Historic Preservation Design Review

HP-14-07, 11 E. Liberty St. (City)

Request: Approval for walkway, landscaping and green space

Below: The proposed open space where the courtyard will be constructed.

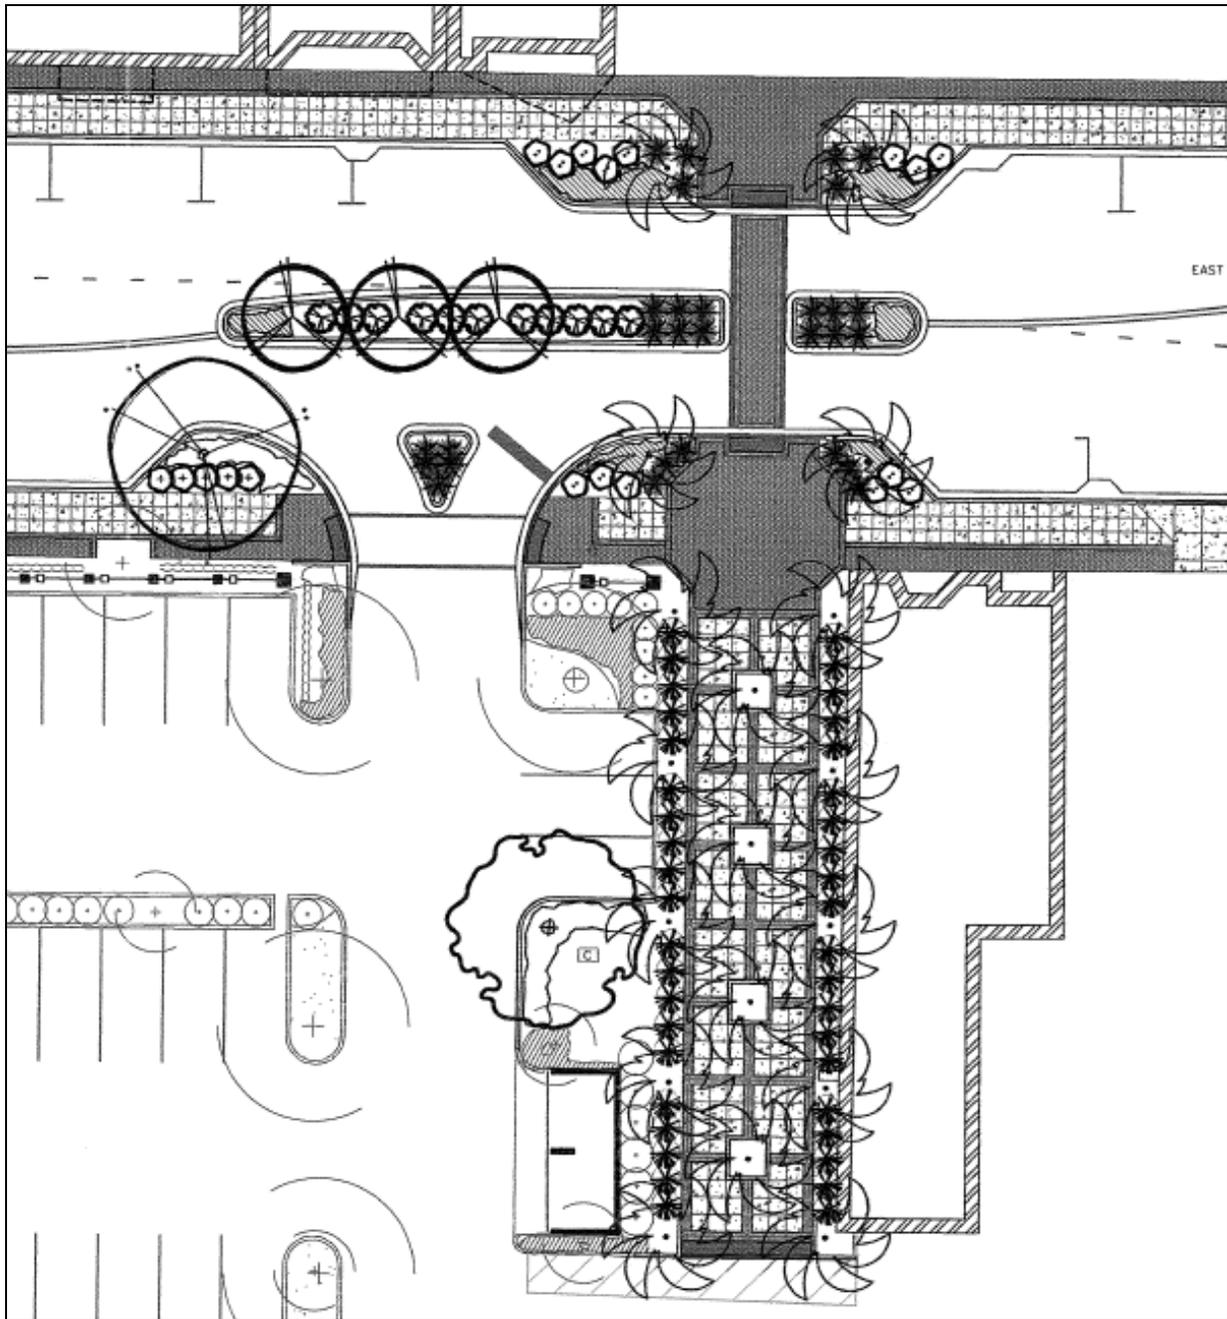
The applicant is seeking approval to construct a landscaped courtyard in the vacant space between the proposed Subway restaurant and a city parking lot (*below*).

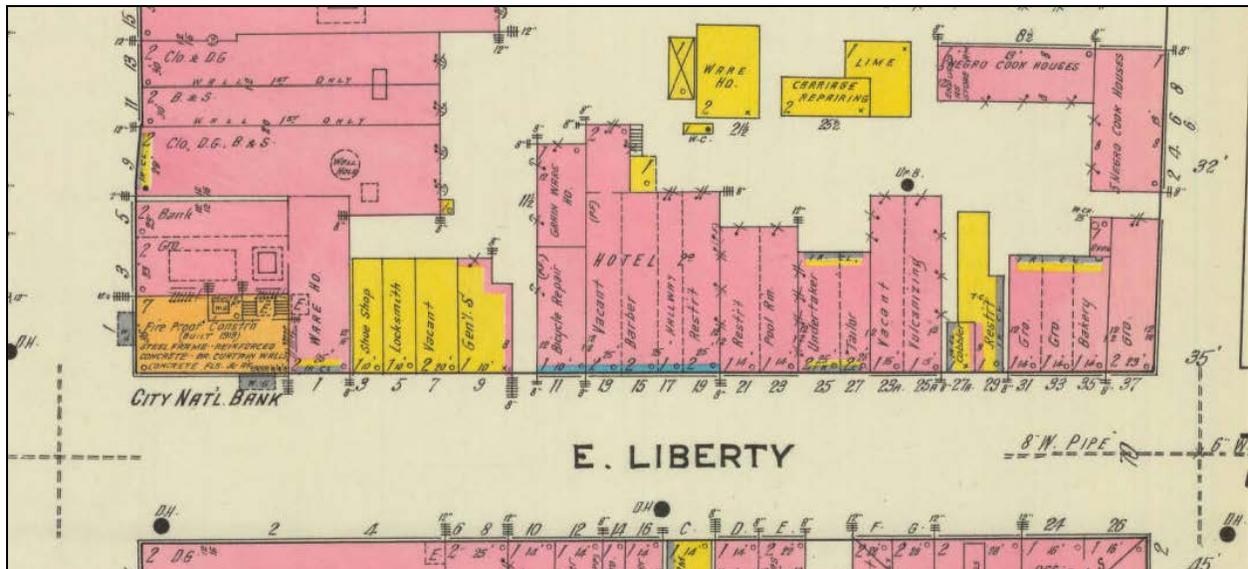
- The trees specified are Palmettos. The estimated mature heights of these trees are approximately 30'. The trees are shown on the plan as being spaced closely in order to provide some shade in the space.

- The submitted plan meets the criteria listed above.

- The submitted plans call for relocating existing lamppost, which is the same lighting as is used elsewhere in the downtown. Likewise, the brickwork is to match existing. (See photo, **Right**)

Planning Staff finds the request generally conforms to applicable Design Review Guidelines.

The Sumter Historic Preservation Design Review Committee at its meeting on Thursday, June 26, 2014, voted to approve this request in accordance with the materials, photographs, and details submitted and referenced in the Staff Report.
